SPRING STREET ELEMENTARY SCHOOL

Spring Street
Shrewsbury, MA 01545

PROJECT: TOWN OF SHREWSBURY ACCESSIBILITY PROJECT
 SPRING STREET ELEMENTARY SCHOOL
 DRAWING: FLOOR PLAN
 SCALE: 1/32" = 1'-0"
 DATE: FEBRUARY 2002

FIRST FLOOR PLAN

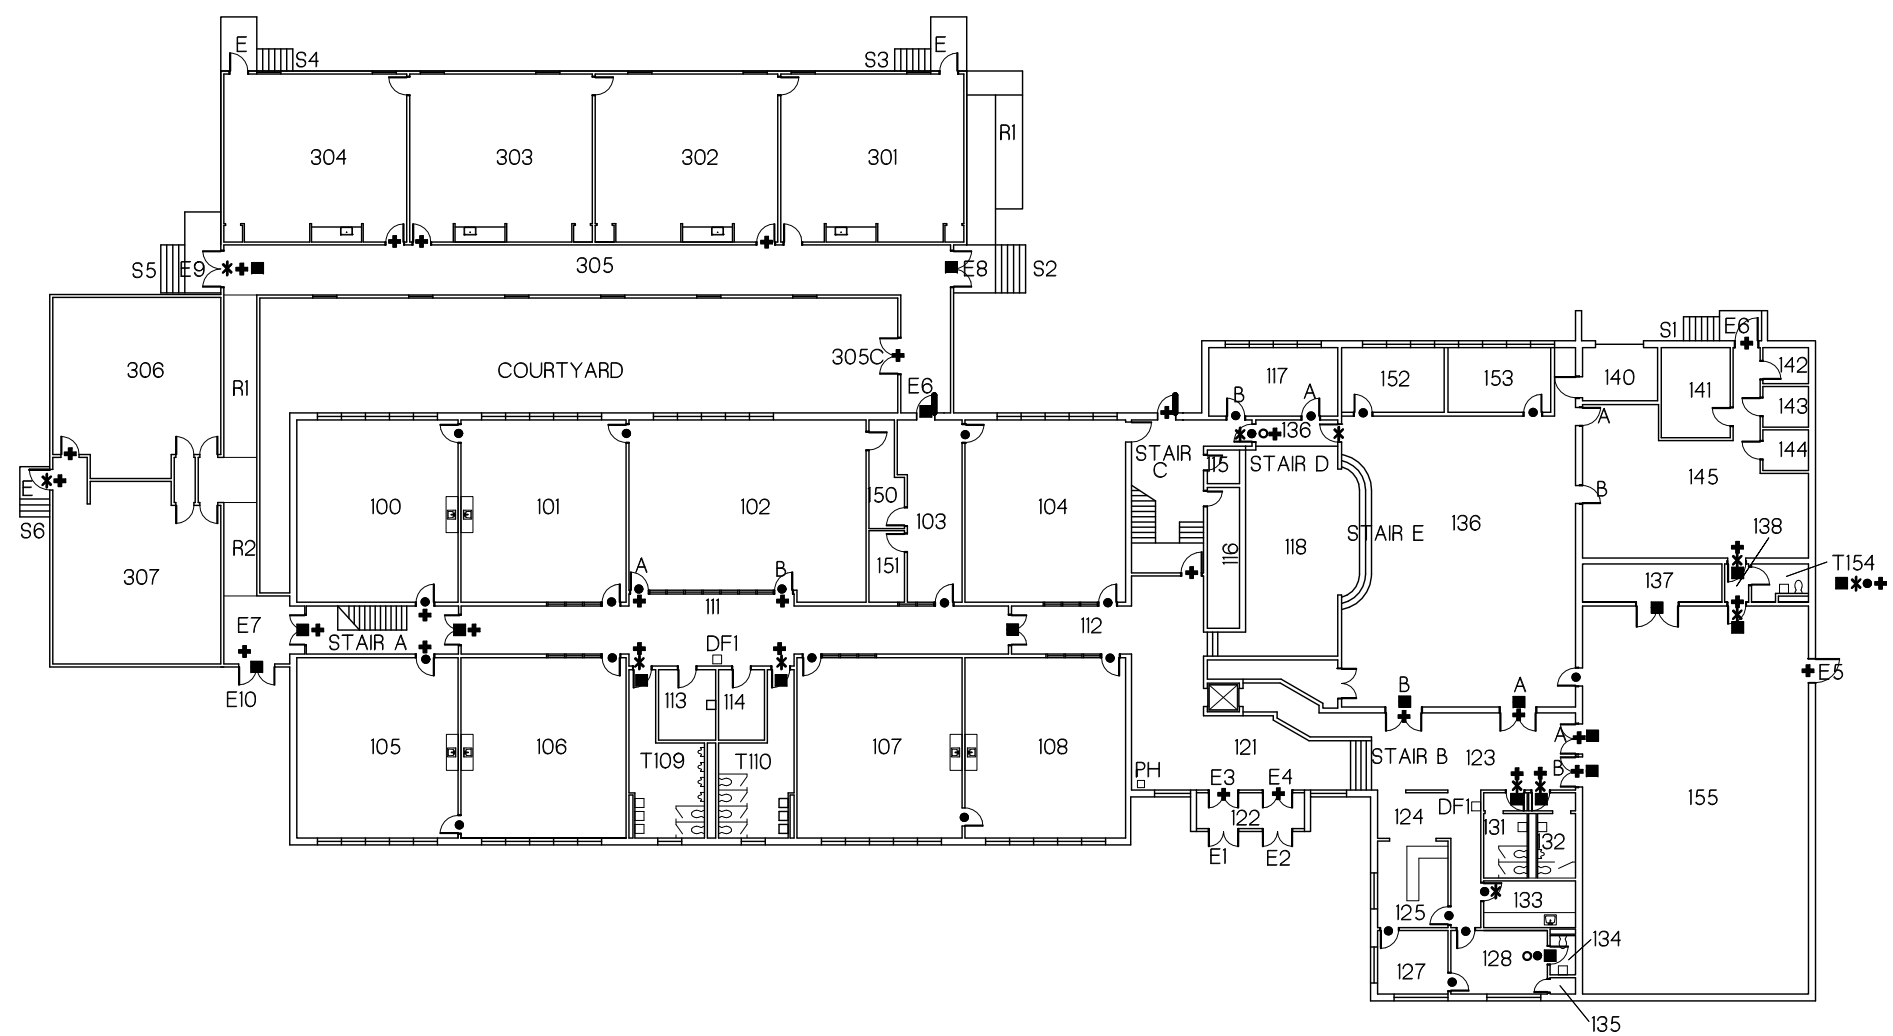
<i>Item</i>	<i>Action Required</i>	<i>Est. Cost</i>	<i>Priority</i>	<i>Feasibility</i>
20 doors do not have the required 32" clearance.	Correct doors E6 and E7-Stair by removing center mullion. Correct doors T109; T110; T209; T210 and T214 by relocating doors. Correct double doors StairA-111; 112-111; 123-136StairA-211 and 212-211 by removing both leafs and installing a 36" eide leaf and a smaller leaf. All other non-conforming doors lead to non-accessible spaces.	33,000	2	3
15 doors do not have the required clearance from pull side	Doors T109; T110; T209 and T210 will be corrected as listed above. Remove door 133-124. All other doors lead to non-accessible spaces or is extremely difficult to accomplish.	-	-	-
44 doors do not have hardware that is operable with a closed fist.	Replace knob with lever hardware	8,000	2	2
35 doors have closers that close too fast or are too hard to operate.	Replace or adjust closers.	15,000	2	2
